UNITED STATES PATENT AND TRADEMARK OFFICE

APPLICATION NO.	FILING DATE	FIRST NAMED INVENTOR	ATTORNEY DOCKET NO.	CONFIRMATION NO.
10/724,262	12/01/2003	Osamu Okumura	117757	1628
25944	7590	11/25/2005	EXAMINER	
OLIFF & BERRIDGE, PLC				CALEY, MICHAEL H
P.O. BOX 19928				ART UNIT
ALEXANDRIA, VA 22320				PAPER NUMBER
				2871

Office Action Summary	Application No.	Applicant(s)
	10/724,262	OKUMURA, OSAMU
	Examiner Michael H. Caley	Art Unit 2871

DETAILED ACTION

FIG. 20A

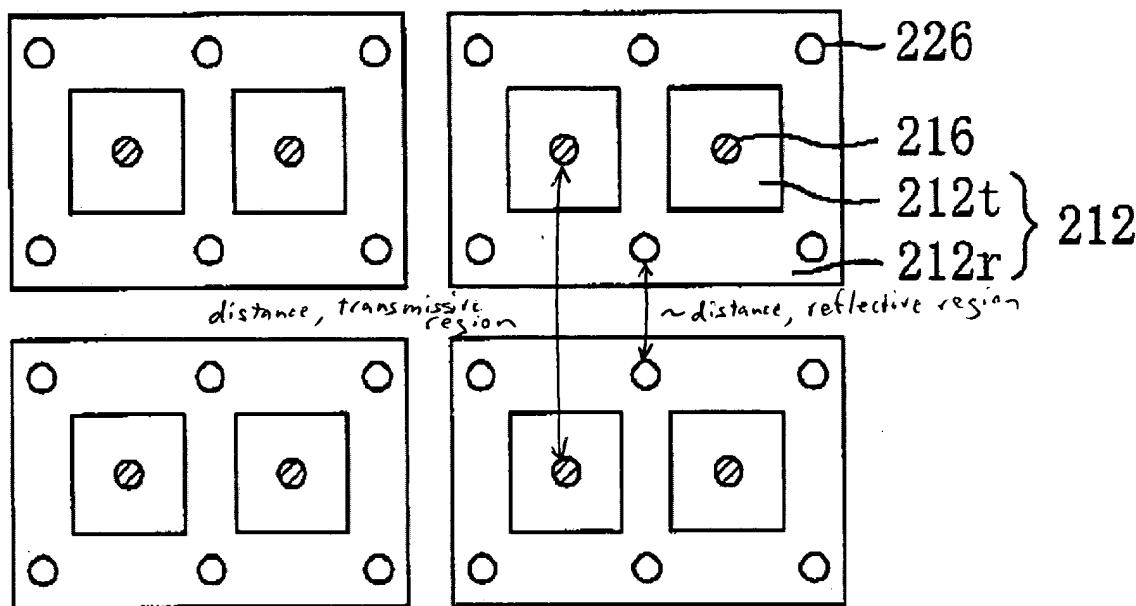
a plurality of alignment controlling elements (Figures 18A and 18B elements 216 and 226) controlling the alignment of the liquid crystal in each of the transmissive display region and the reflective display region, the alignment controlling elements provided on the electrode of at least one of the pair of substrates, the occupying area of the alignment controlling elements in a plane direction of the substrate being set larger in the reflective display region than in the transmissive display region (Figures 18A and 18B), the distance between adjacent two of the alignment controlling elements arranged in the reflective display region being smaller than the distance between adjacent two of the alignment controlling elements arranged in the transmissive display region (Figure 20A, vertical direction).

Regarding claim 14, Ogishima discloses the distance between adjacent two of the openings and/or protrusions arranged in the reflective display region as being smaller than the

distance between adjacent two of the openings and/or protrusions arranged in the transmissive display regions (Figure 20A, vertical direction).

FIG. 54

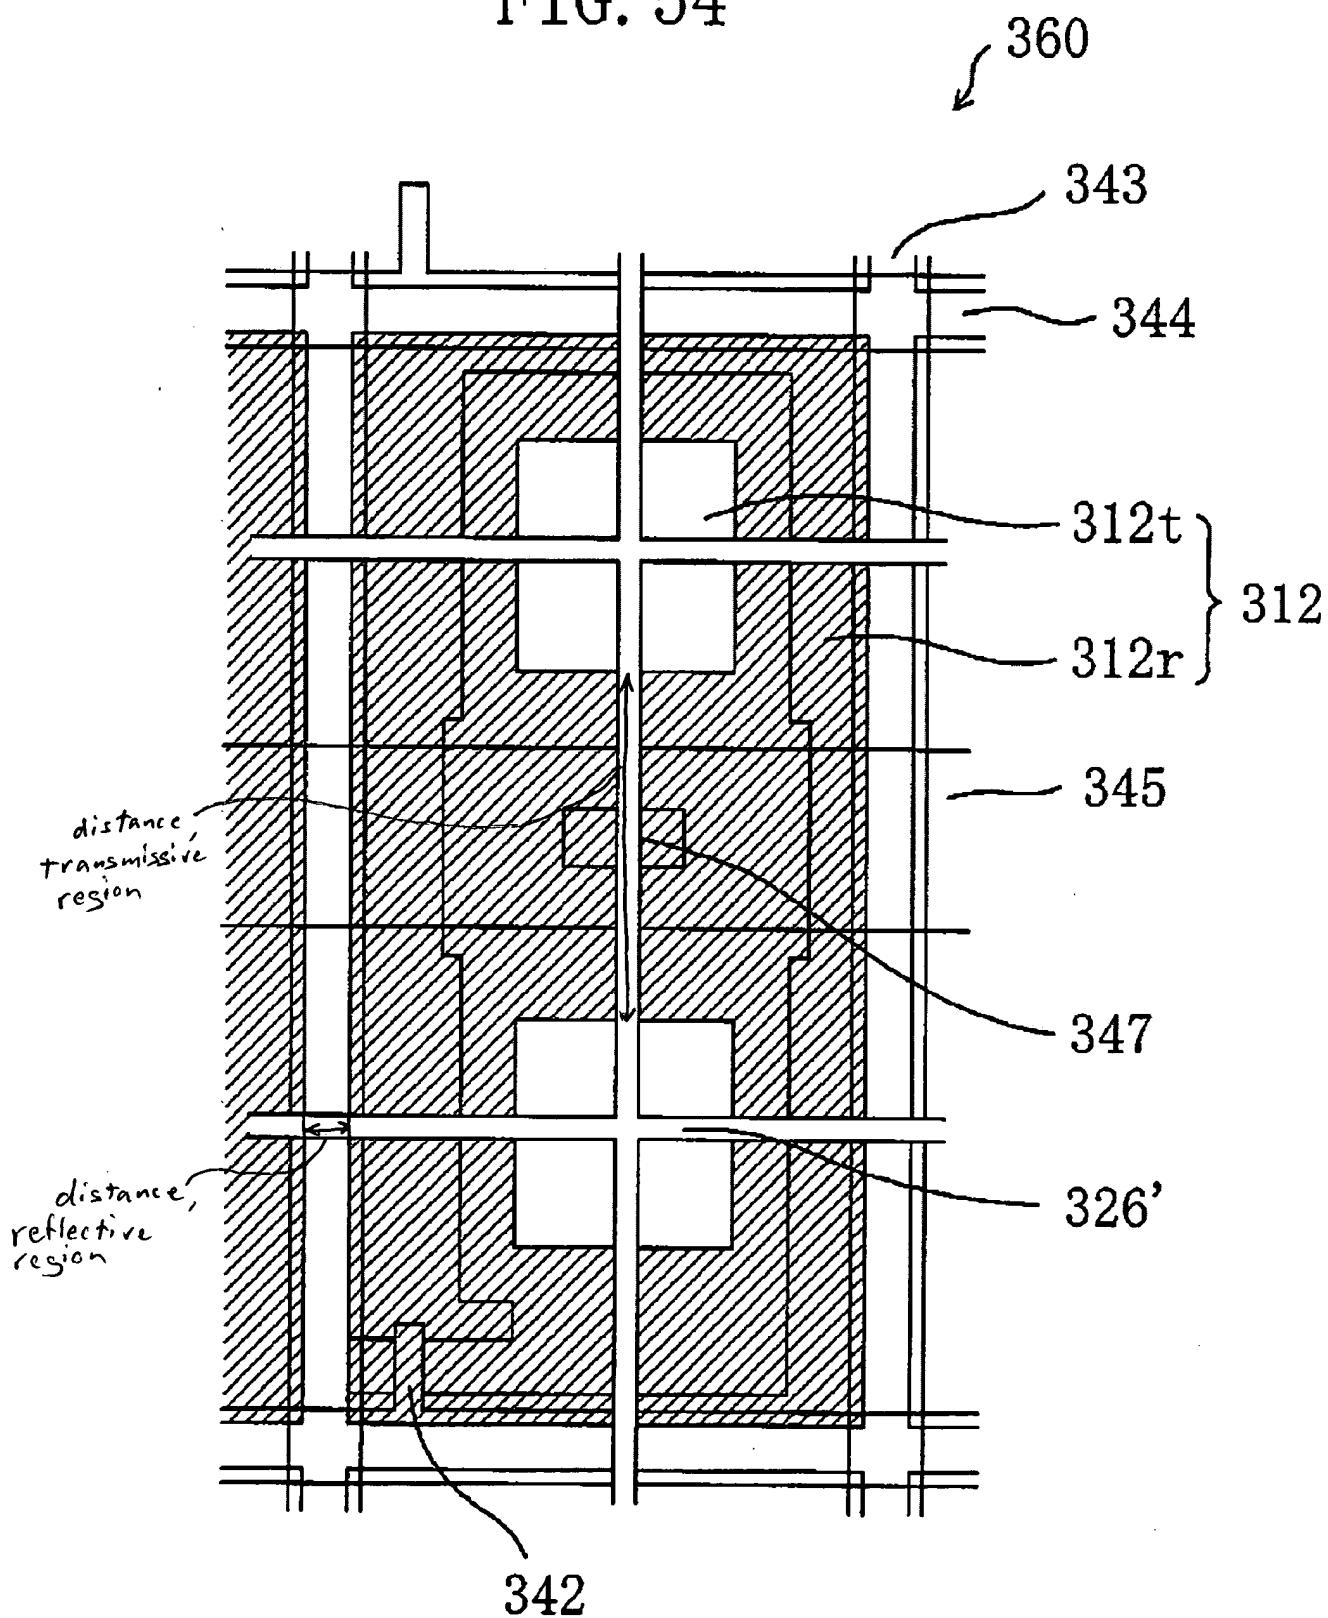
a plurality of alignment controlling elements (Figure 54 element 347) controlling the alignment of the liquid crystal in each of the transmissive display region and the reflective display region, the alignment controlling elements provided on the electrode (Figure 53) of at least one of the pair of substrates, the alignment controlling elements each having a linear portion that extends across one dot region.

Ogishima fails to explicitly disclose the occupying area of the alignment controlling elements in a plane direction of the substrate as being set larger in the reflective display region than in the transmissive display region. Ogishima discloses a variety of embodiments such as in Figure 54, which show linear alignment controlling elements in both the transmissive and reflective display regions. Kubo teaches increasing the area percentage of the reflective region to transmissive region to up to 90% in an analogous transreflective display as an optimization of the display such as for use outdoors and to lengthen battery life (Column 29 line 64 – Column 30 line 22).

Regarding claim 9, Ogishima discloses the alignment controlling elements as dielectric protrusions being arranged on the electrode (Figure 54 element 326')

Regarding claims 4, 10, 13-15, and 18, Ogishima discloses the distance between adjacent two of the openings and/or protrusions arranged in the reflective display region as being smaller than the distance between adjacent two of the openings and/or protrusions arranged in the transmissive display regions (Figure 54, distance between horizontally adjacent protrusions between reflective display dot regions are smaller than distance between vertically adjacent protrusions in transmissive region, see Figure below).

Regarding claim 6, Ogishima discloses the lower substrate having a reflective film on a side facing the liquid crystal layer (Figure 54 element 312r), the reflective layer being selectively arranged only in the reflective display regions in one dot region (Figure 54 elements 312R and 312T).
